**Ordinance Number: 1365-23, File Number: 19-24**

**RTA Tunnel Membrane Replacement- Addendum 3**

**NARRATIVE:** Addendum 3 contains the following:

Sheet Title: **TUNNEL REPAIR - WATERPROOFING DETAILS**

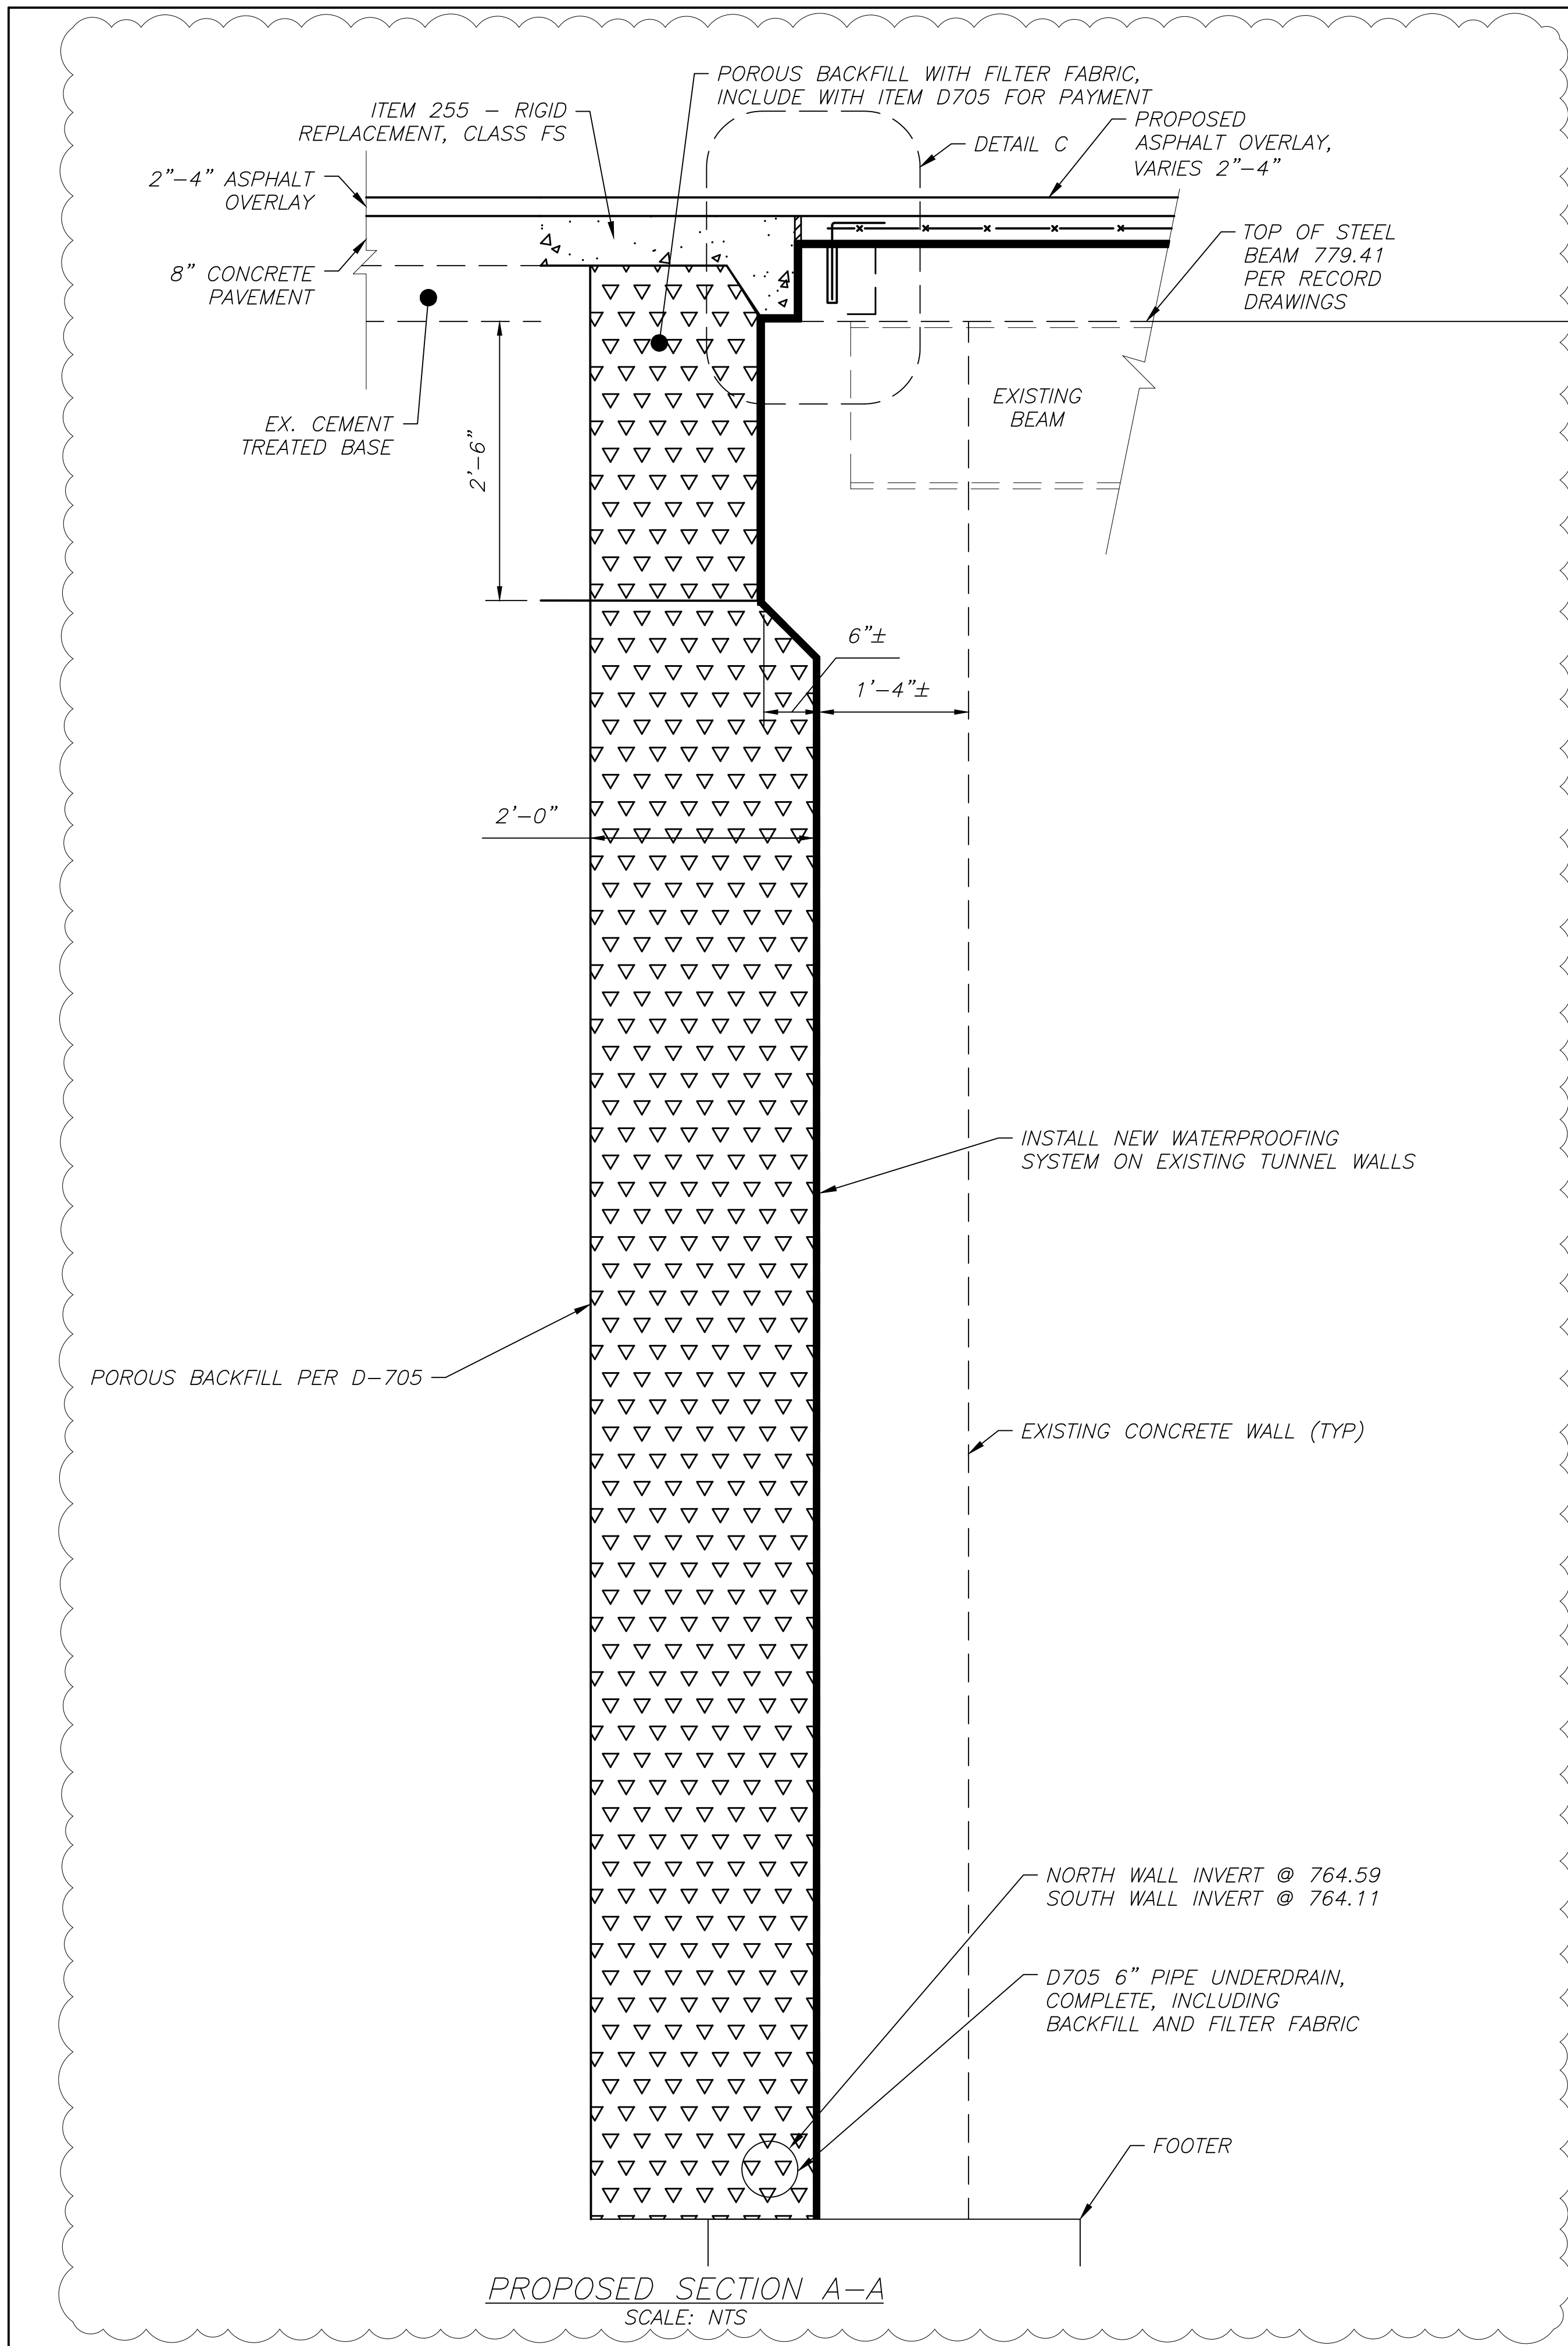
Question: Plan Sheet C-17, Foam Flashing Detail, states to provide "premolded joint material". Please provide specified type and size to be installed.

*Answer: The foam flashing detail has been removed. Please see Sheet C-19 for flashing details.*

Scale: AS SHOWN    Project No.: 198348  
Date: FEBRUARY 2024    Sheet: C-25

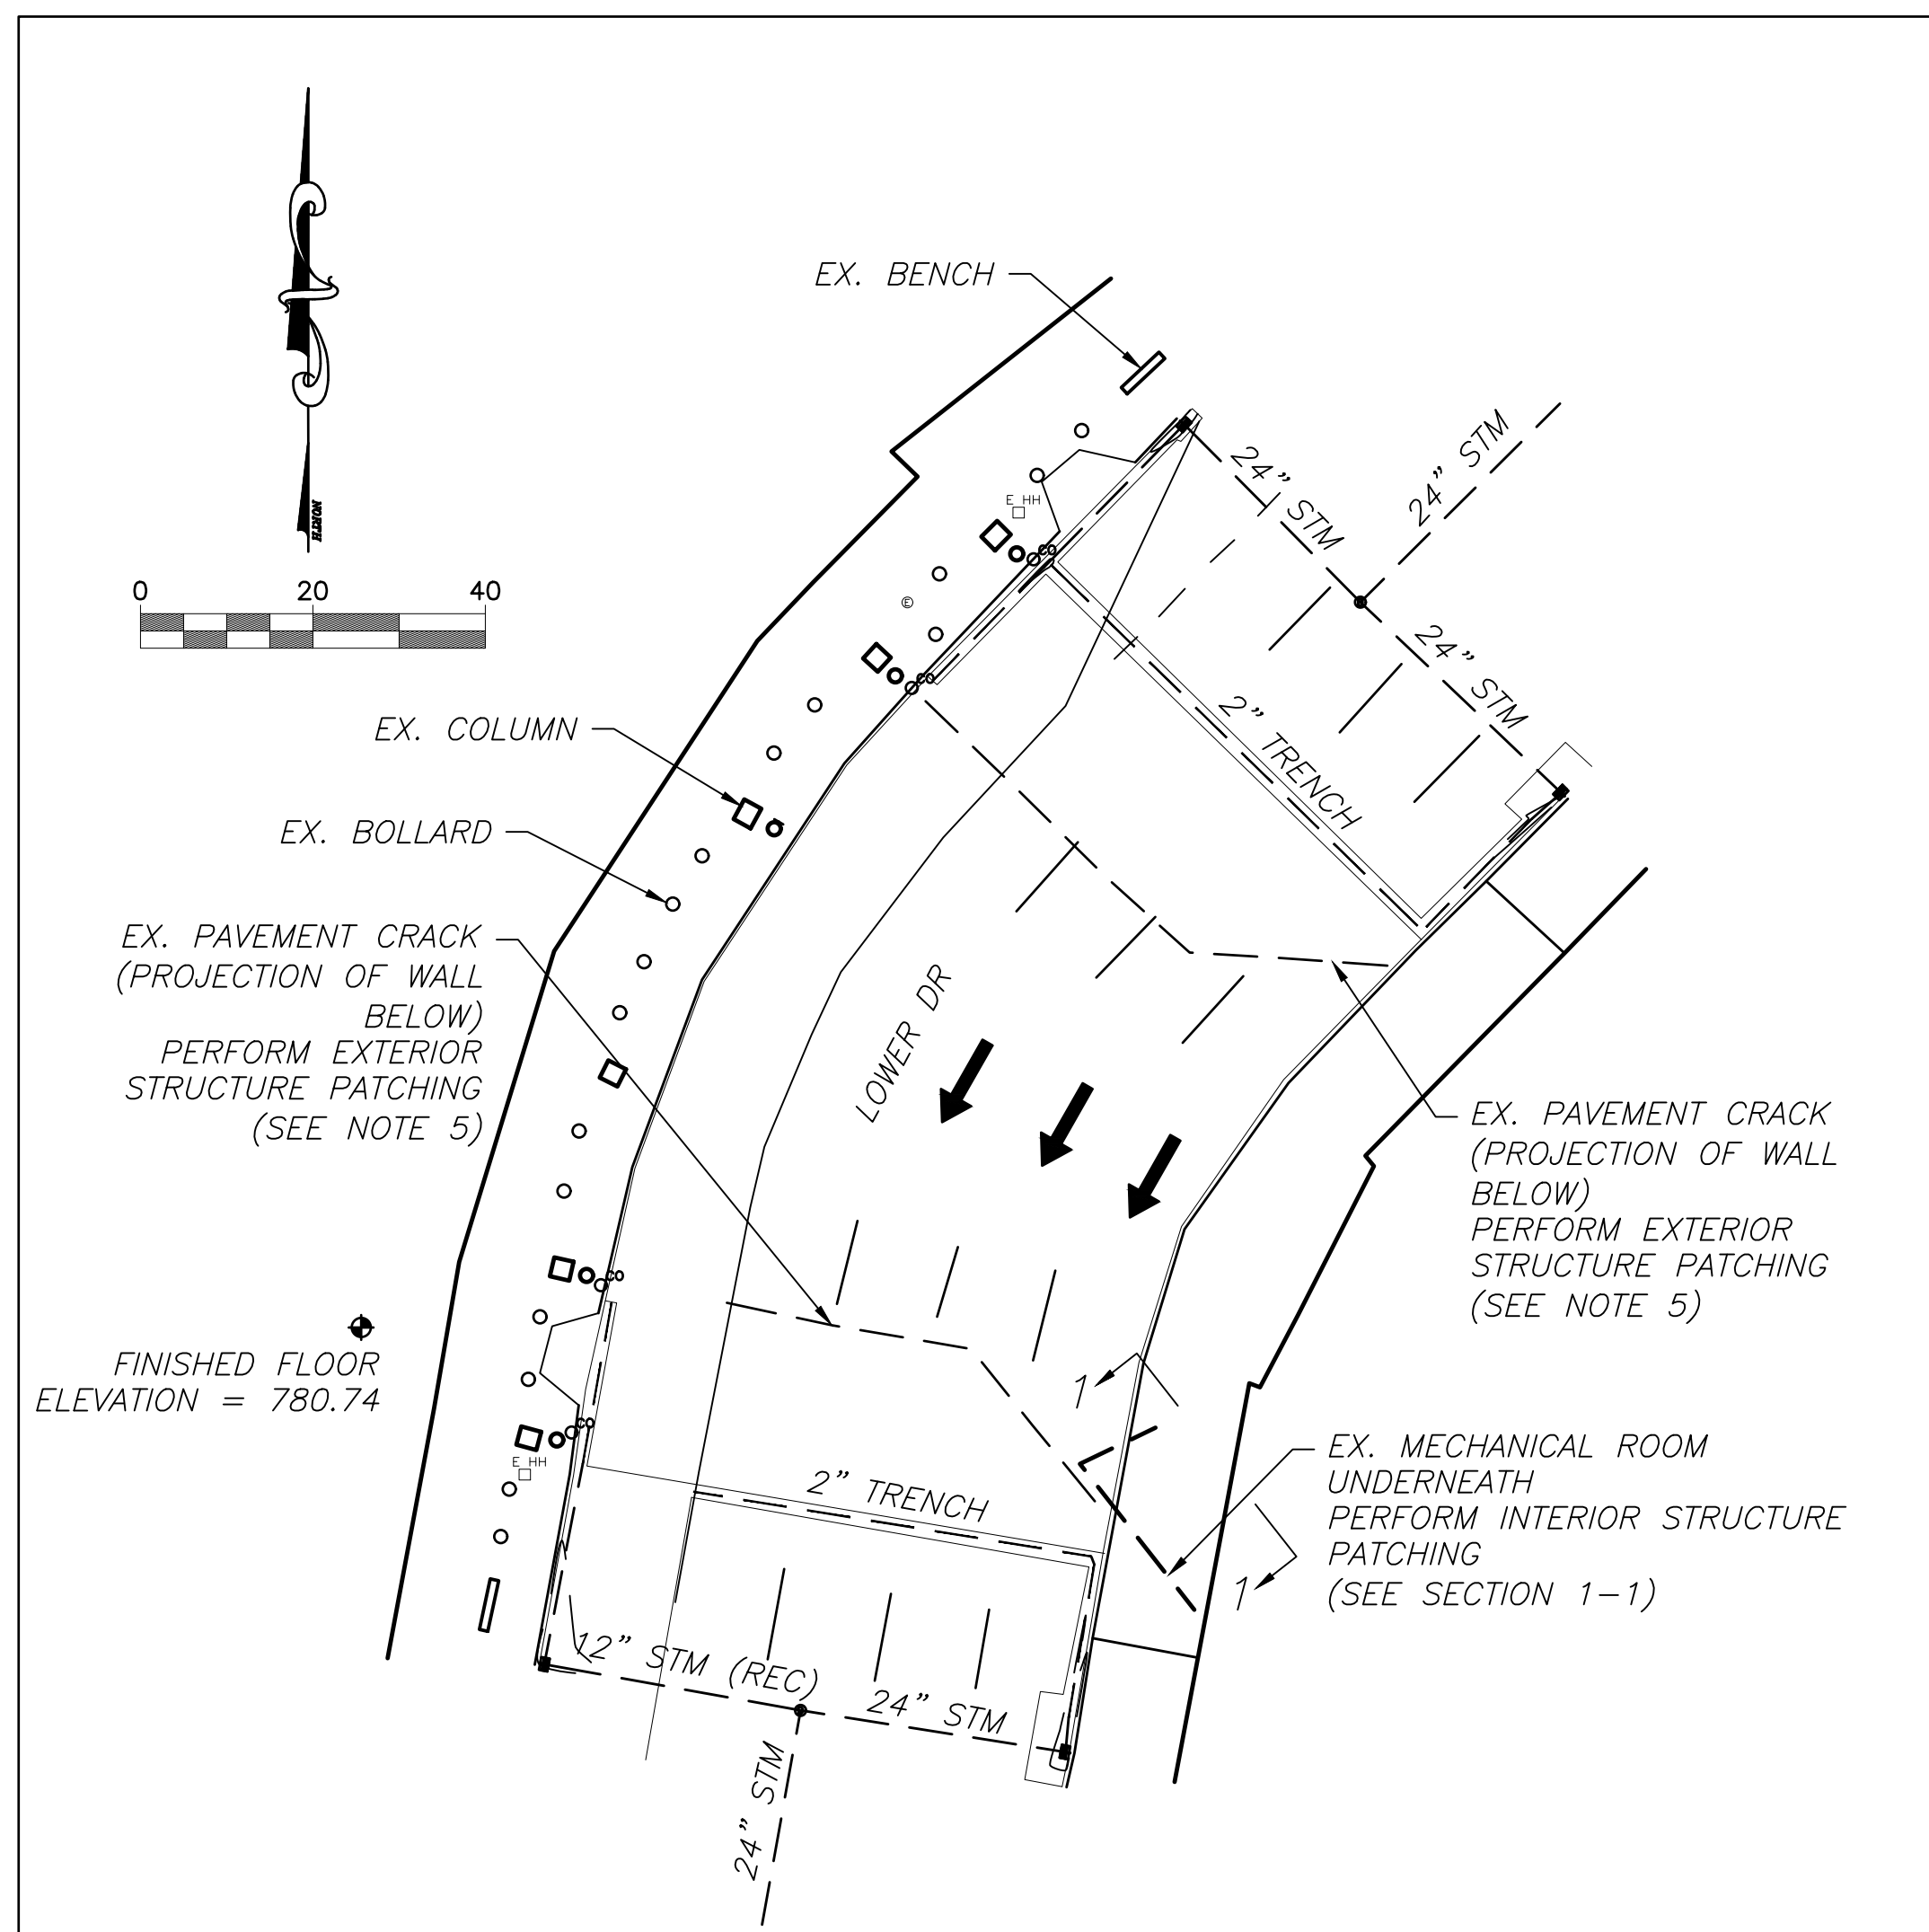
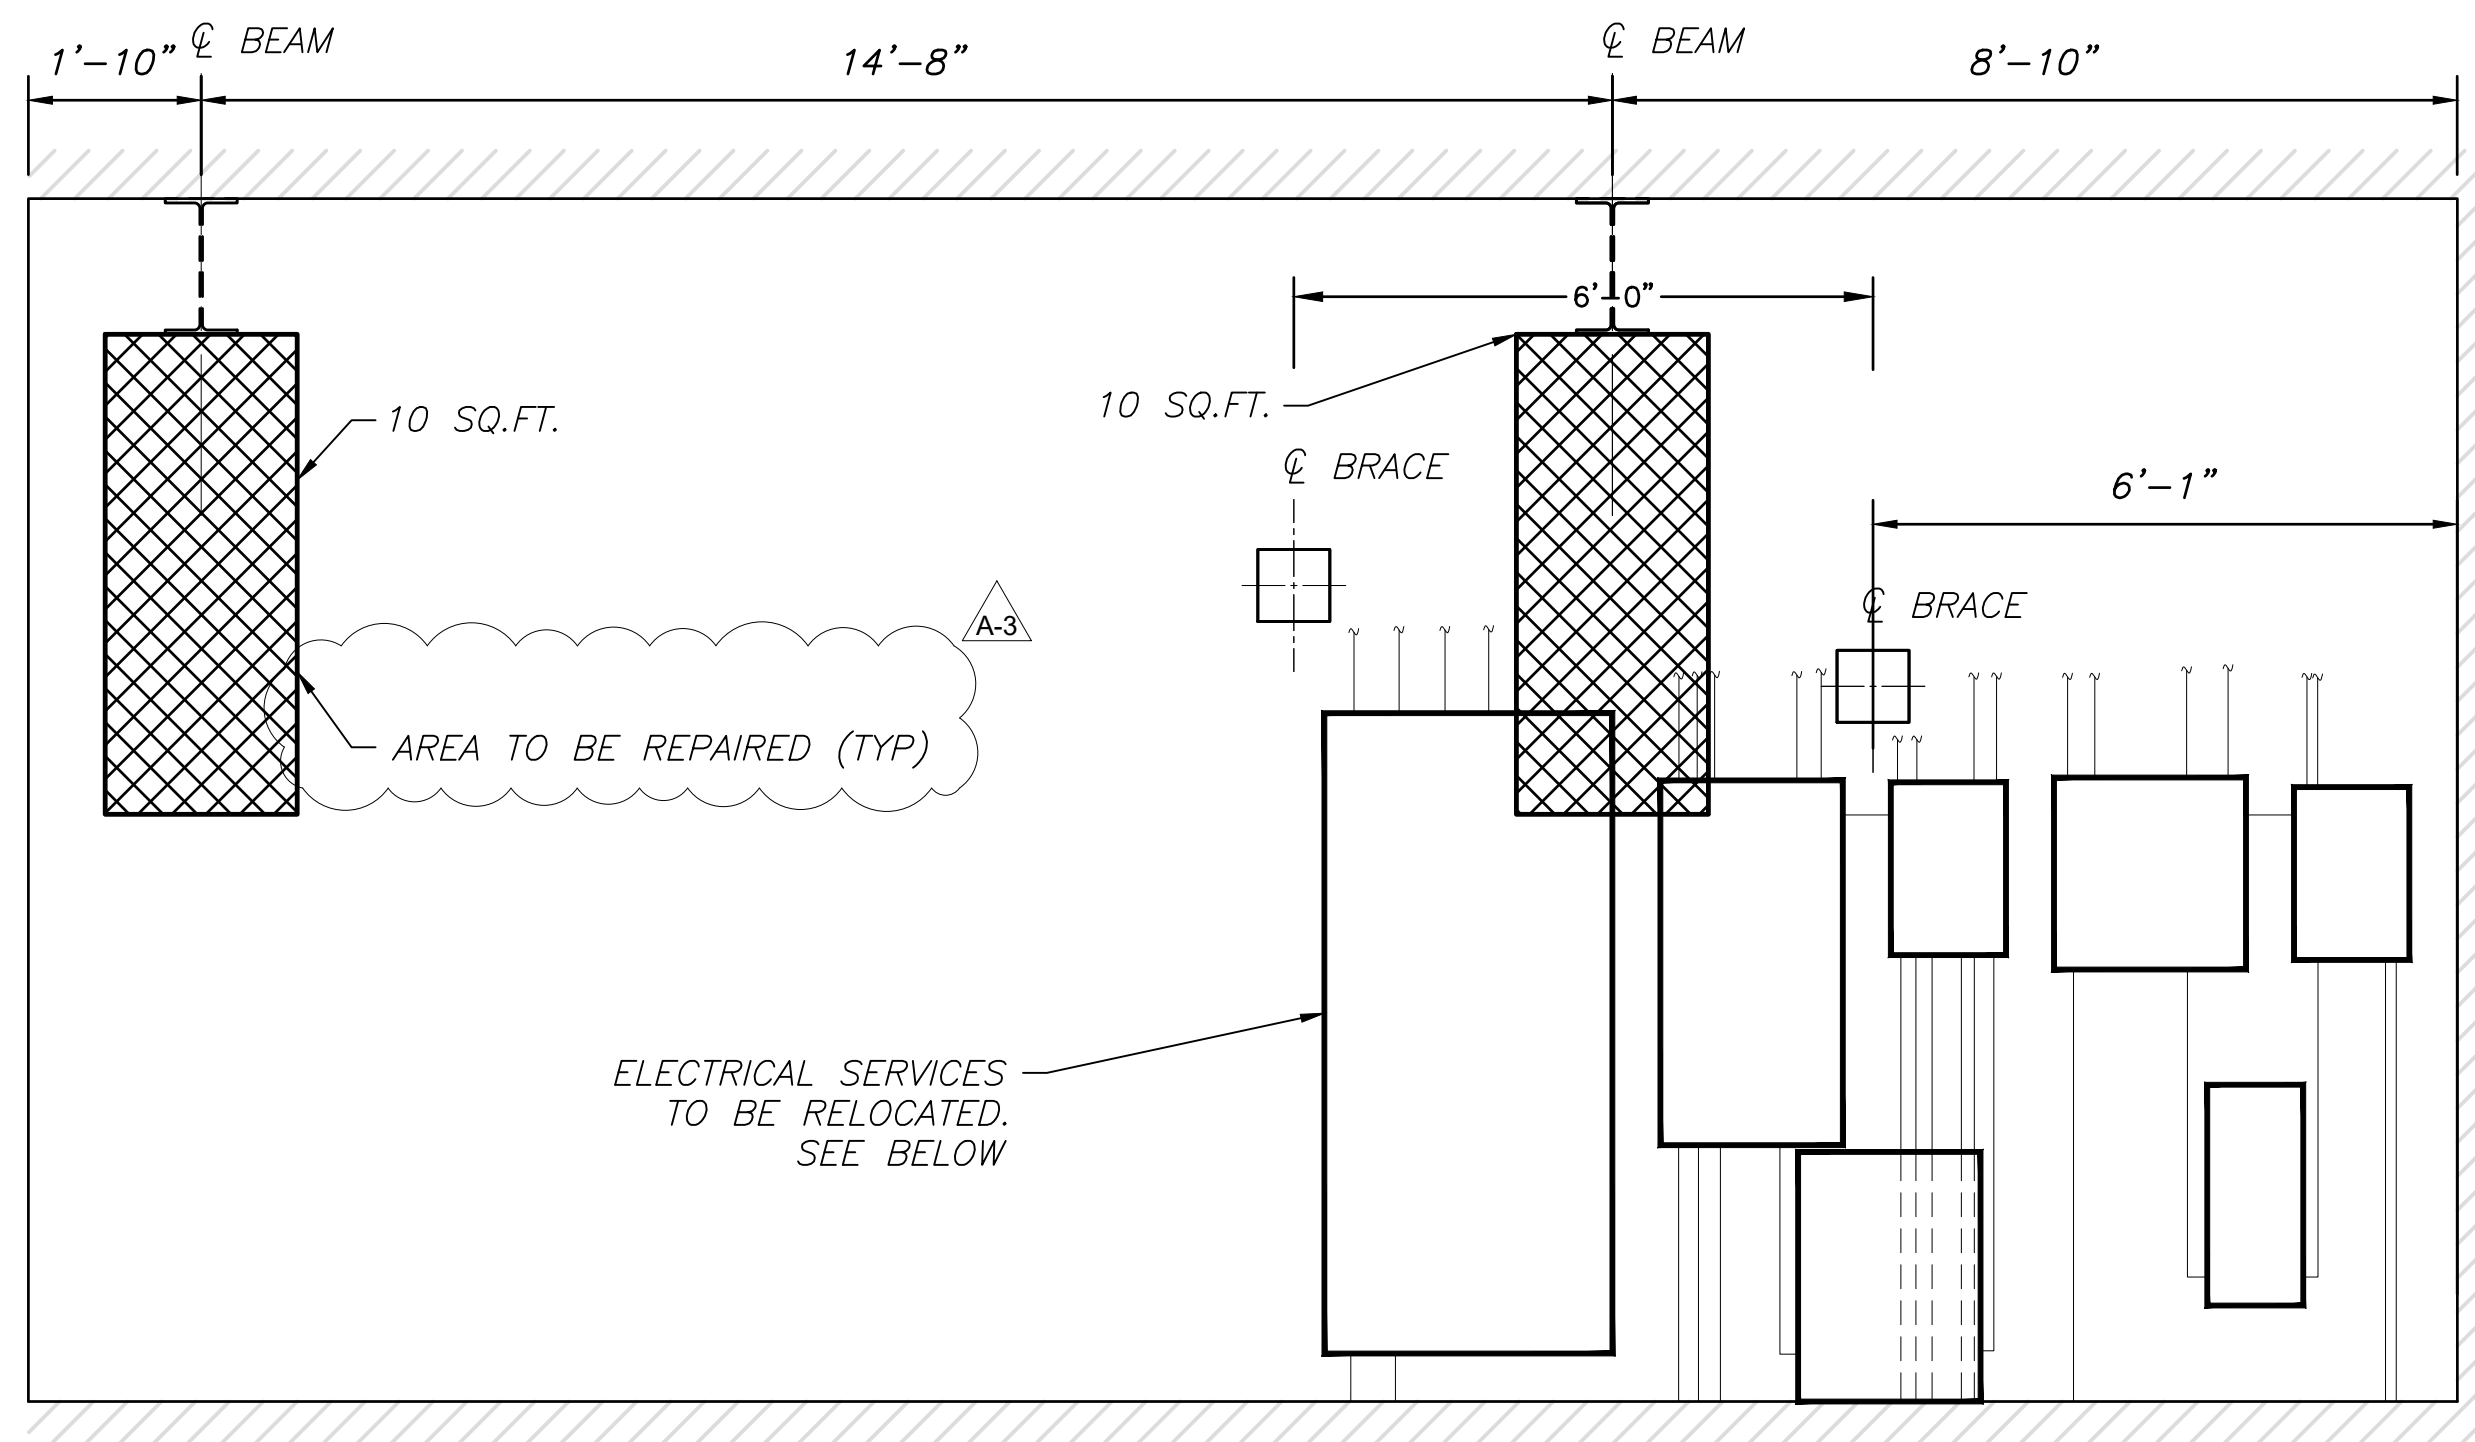
1. THE CONTRACTOR TO FOLLOW ODOT ITEM 519 - PATCHING CONCRETE STRUCTURES SPECIFICATIONS WHEN PERFORMING THE PATCHING WORK.
2. THE LOCATIONS SHOWN ON THE PLANS ARE APPROXIMATE. NO DETAILED INSPECTION WAS PERFORMED. PATCH AREAS TO BE FIELD LOCATED BY THE CONTRACTOR AND APPROVED BY THE RESIDENT PROJECT REPRESENTATIVE (RPR). THE CONTRACTOR WILL BE PAID FOR THE ACTUAL SQUARE FOOT AREA PATCHED.
